Office Action Summary	Application No. 10/587,062	Applicant(s) KREUPL ET AL.	
	Examiner KHANH DUONG	Art Unit 2822

DETAILED ACTION

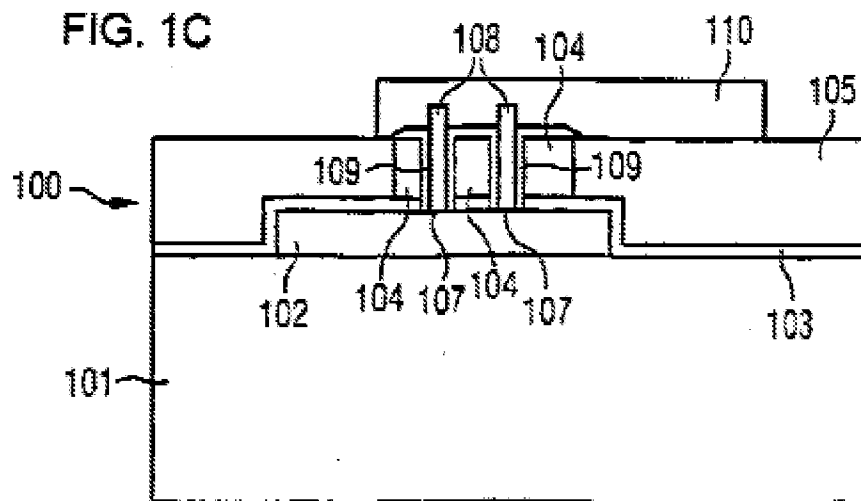
Re claim 23, Roesner et al. (“Roesner”) discloses in FIG. 1C a semiconductor power switch comprising: a source contact 102; a drain contact 110; a semiconductor structure provided between the source contact 102 and the drain contact 110; a gate 104 used to control a current

flow through the semiconductor structure between the source contact and the drain contact; and wherein the semiconductor structure has a plurality of nanowires 108 which are connected in parallel and are arranged in such a manner that each nanowire 108 forms an electrical connection between the source contact 102 and the drain contact 110 [see col. 4, line 60 to col. 6, line 46].

Re claim 25, Roesner expressly discloses in FIG. 1C the gate is implemented in the form of a gate layer 104 which is provided between the source contact 102 and the drain contact 110 and is permeated by the nanowires 108, the nanowires 108 being electrically insulated from the gate layer 104 (by layer 109).

Re claim 26, Roesner expressly discloses in FIG. 1C the gate is implemented in the form of a plurality of gate bands 104 whose longitudinal orientation respectively runs substantially perpendicular to the orientation of the nanowires 108 and whose transverse orientation

corresponds to the orientation of the nanowires 108, the nanowires 108 being electrically insulated from the gate.

Re claim 27, Roesner expressly discloses in FIG. 1C the nanowires run within trenches 106 provided between the gate bands 104.

Re claim 29, Roesner expressly discloses in FIG. 1C tubes (of material 109) are provided within the trenches 106, at least one nanowire 108 respectively running within the tubes.

Re claim 30, Roesner expressly discloses in FIG. 1C insulation layers 109 are provided between the trenches 106 and the gate bands 104.

Re claim 31, Roesner expressly discloses in FIG. 1C the nanowires 108 are insulated from one another.

Re claim 32, Roesner expressly discloses in FIG. 1C the nanowires are at an equal distance from one another.

Re claim 33, Roesner expressly discloses in FIG. 1C the gate layer (the gate bands) 104 has a layer thickness (band width) which is approximately 1/3 of the distance between the source contact 102 and the drain contact 110.
